Rocky Mountain Arsenal  
North Boundary System Component  
Response Action Assessment

Final Technical Plan  
(Version 3.1)  
February 1988  
Contract Number DAAK11-84-D-0016  
Task Number 36

Re: Rocky Mountain Arsenal (RMA),  
Comments on Technical Plans for  
Tasks 25 & 36

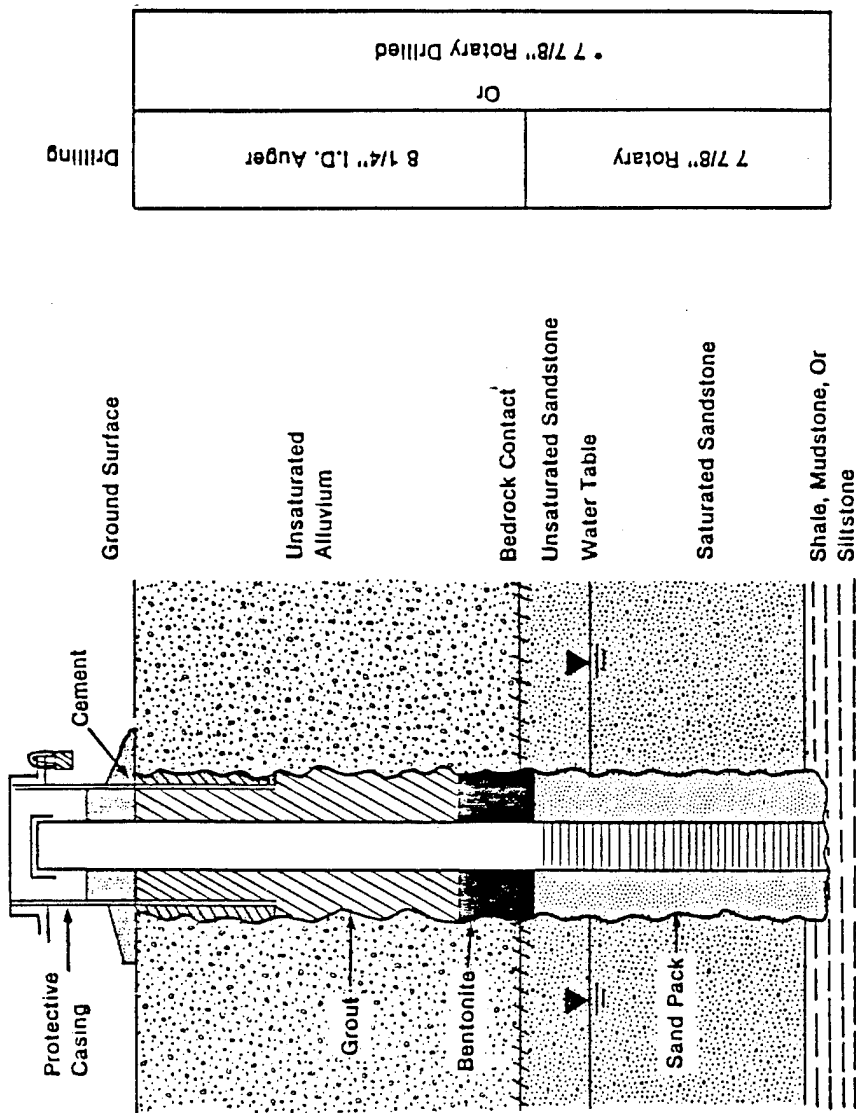
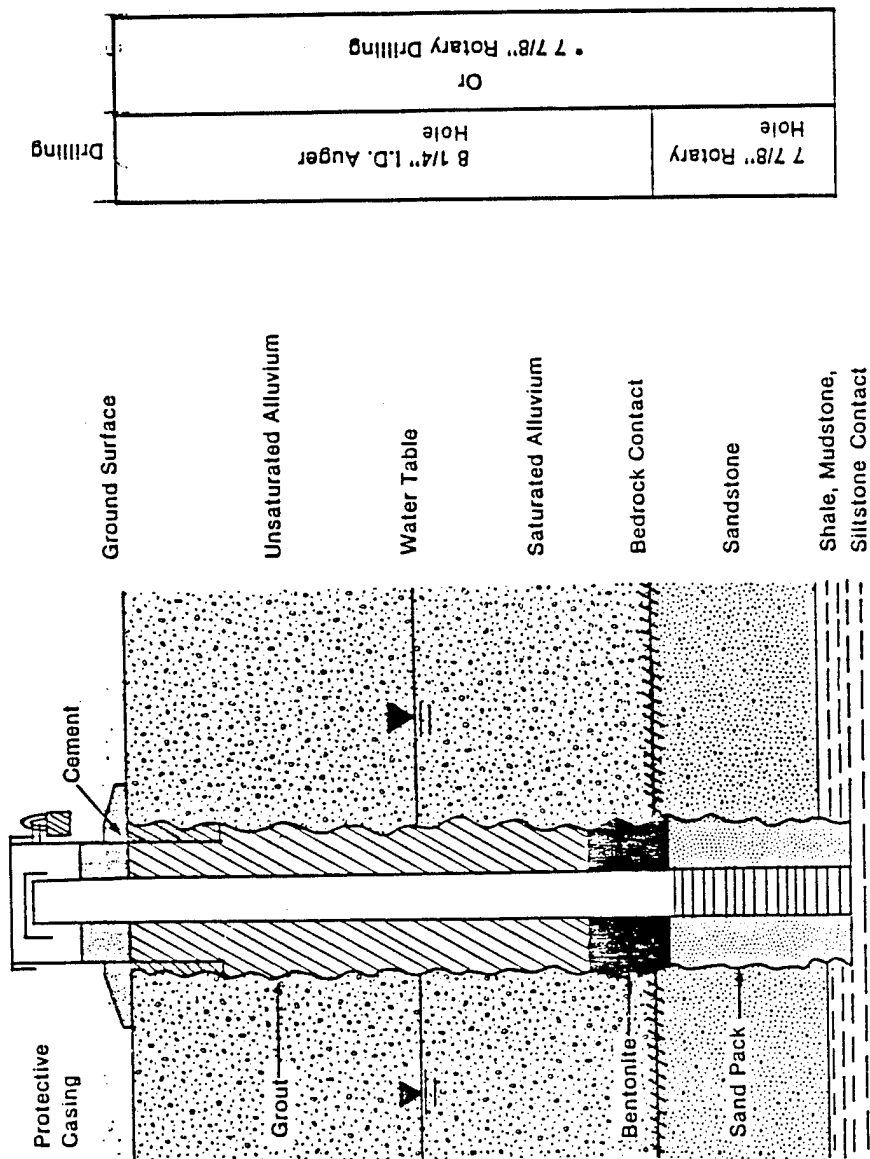
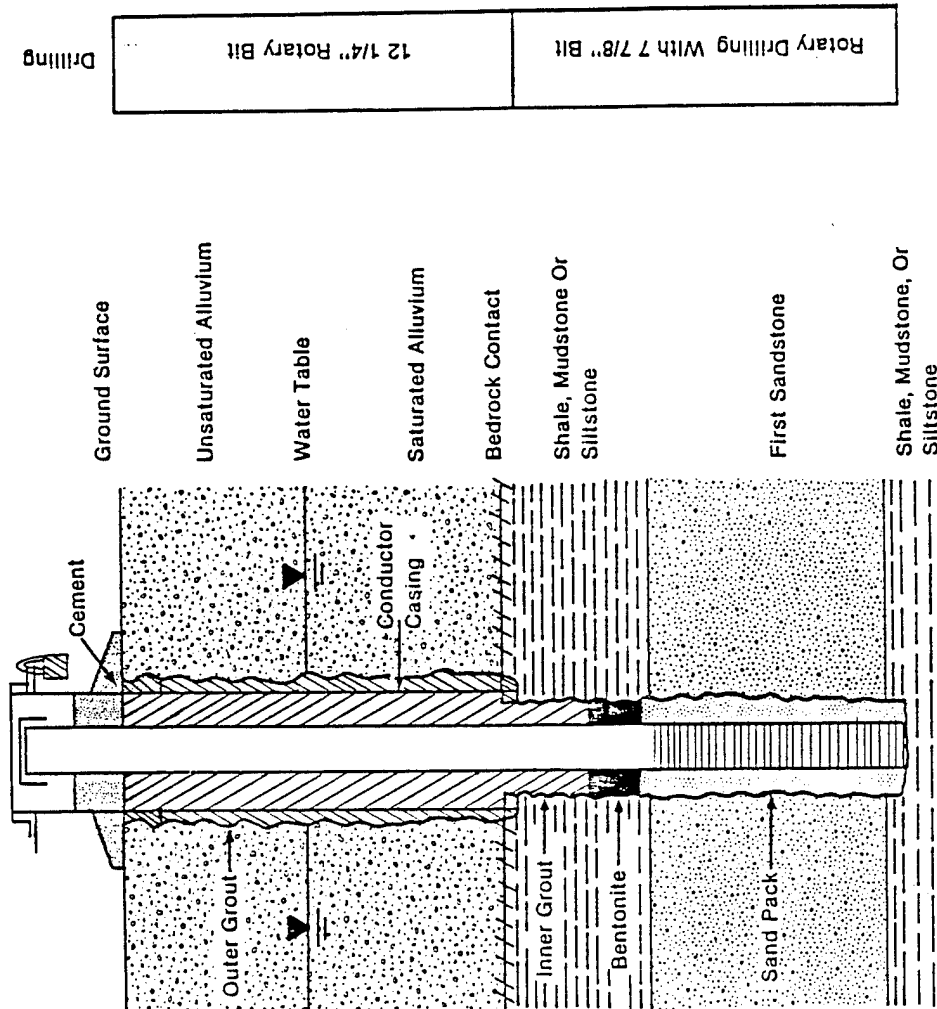
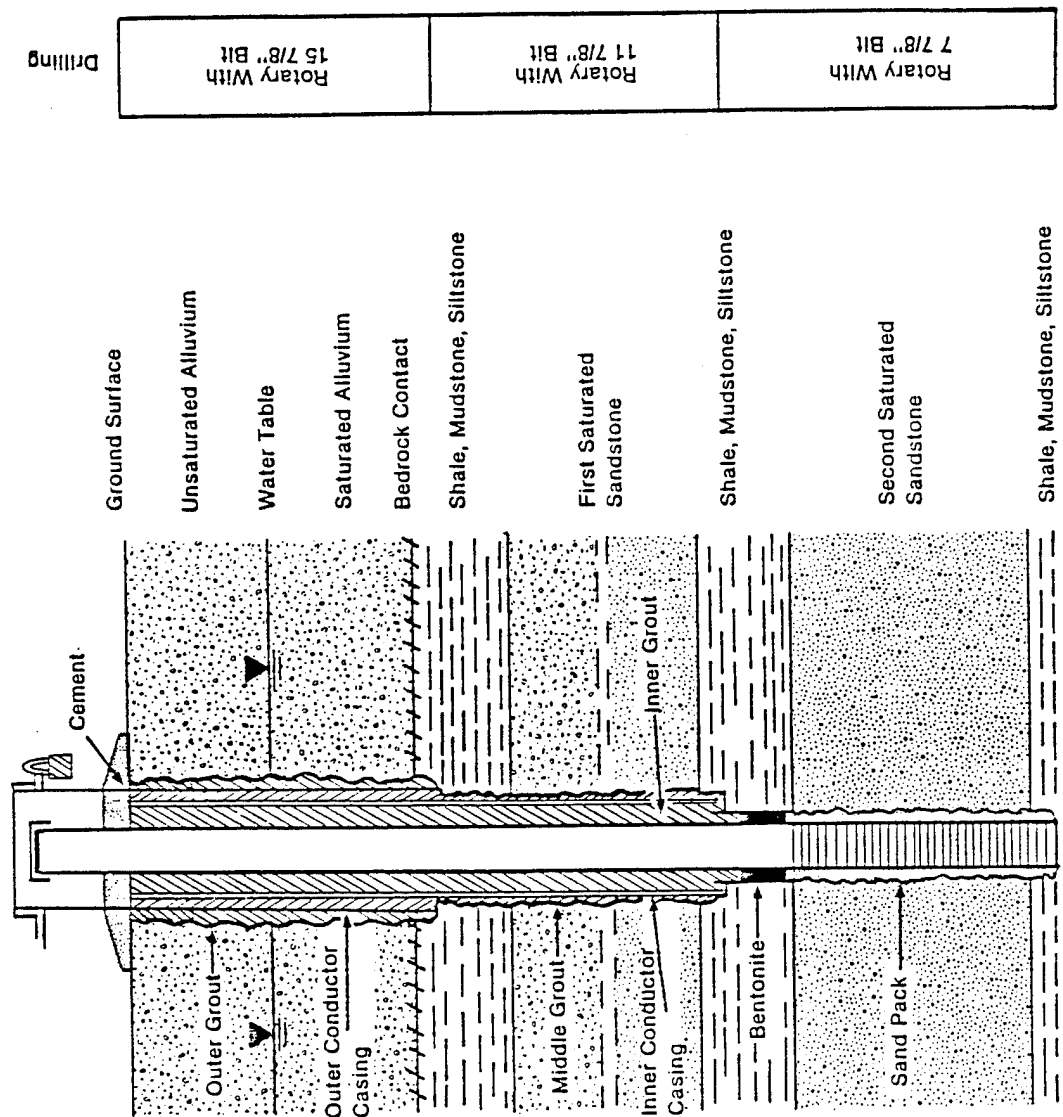
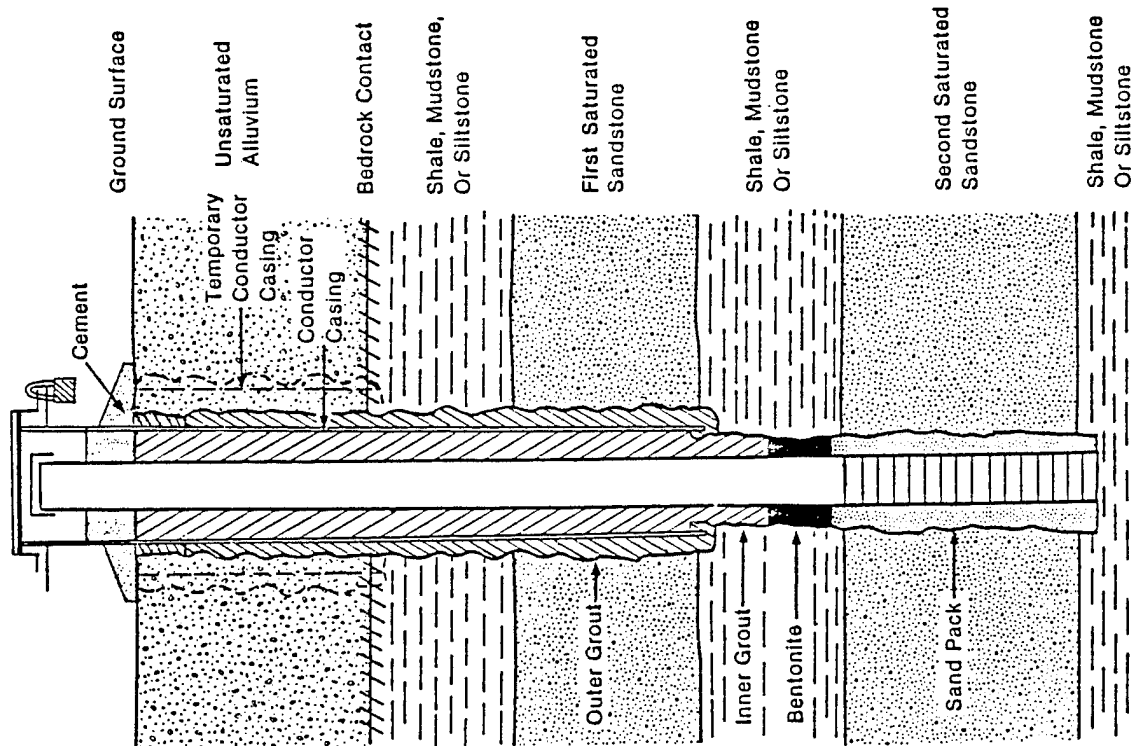
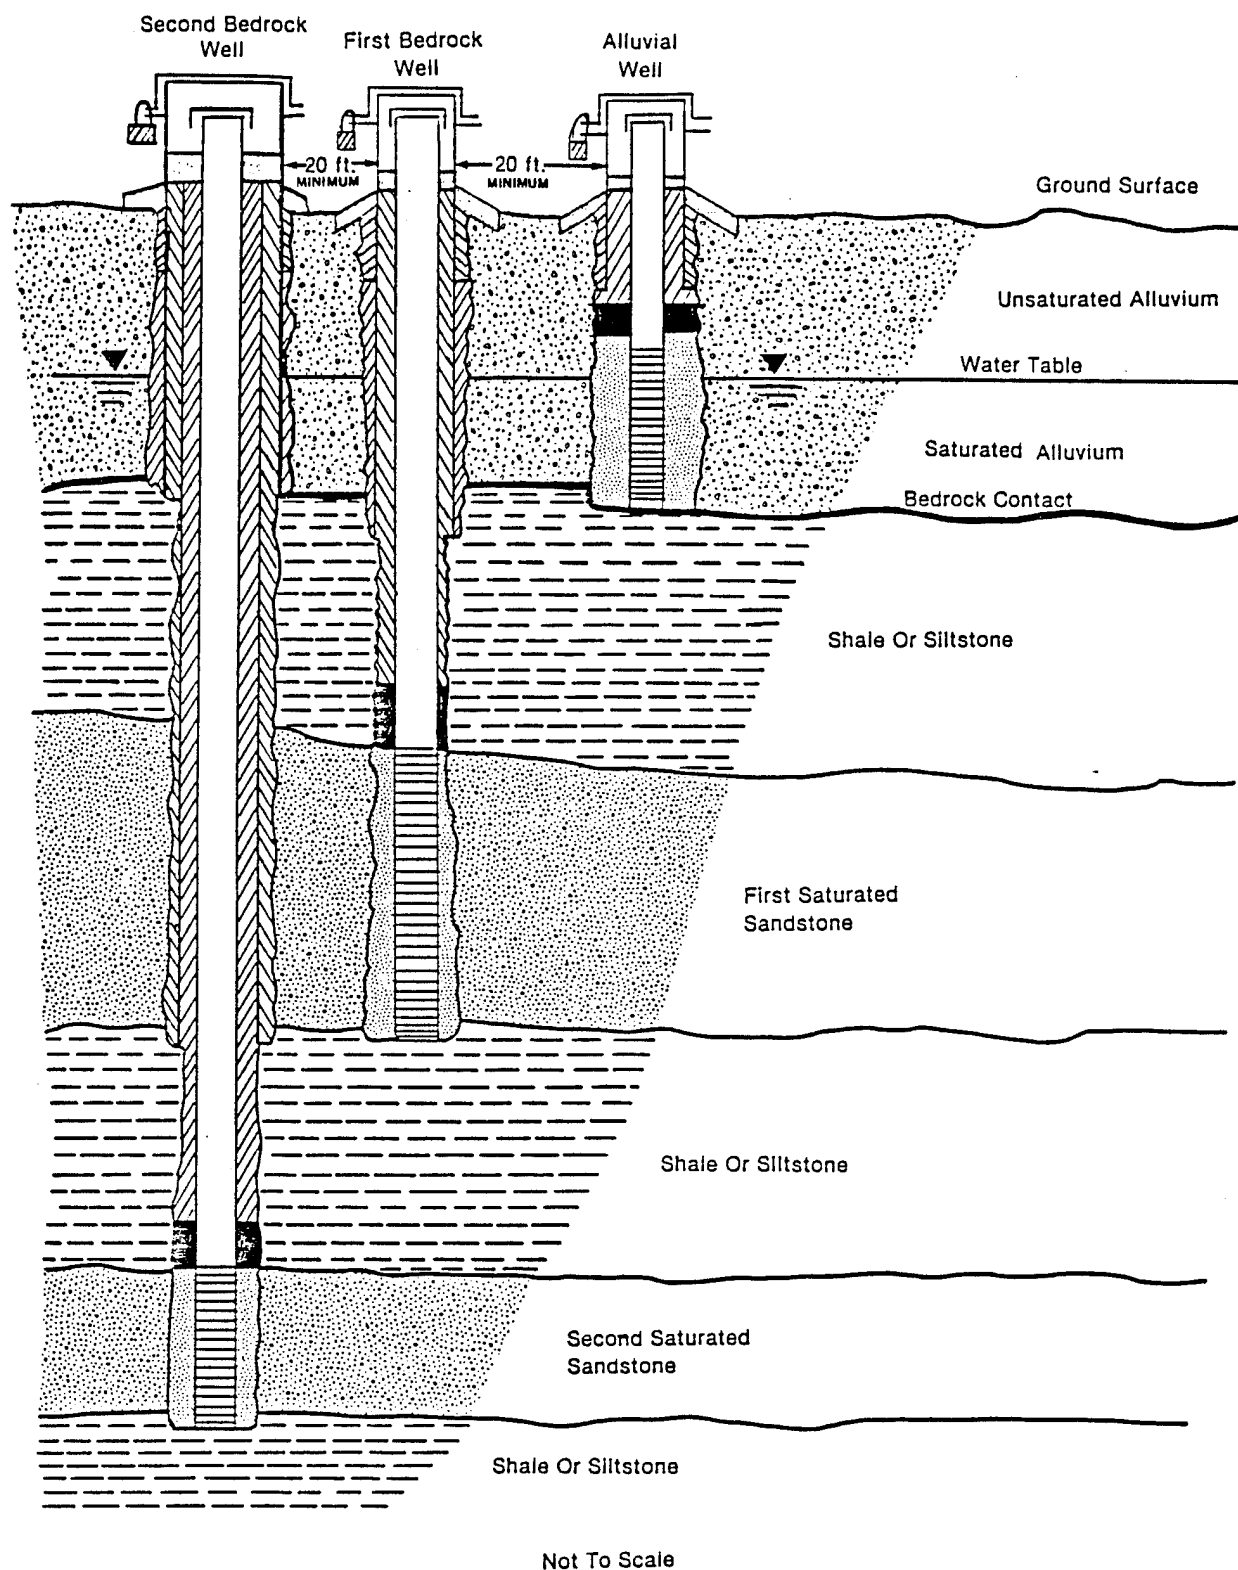
Figures 3.2-2a through 3.2-3. Construction details and contingencies for installing monitoring wells in shales/claystones of the Denver aquifer that show evidence of fracturing must be included in the technical plan.
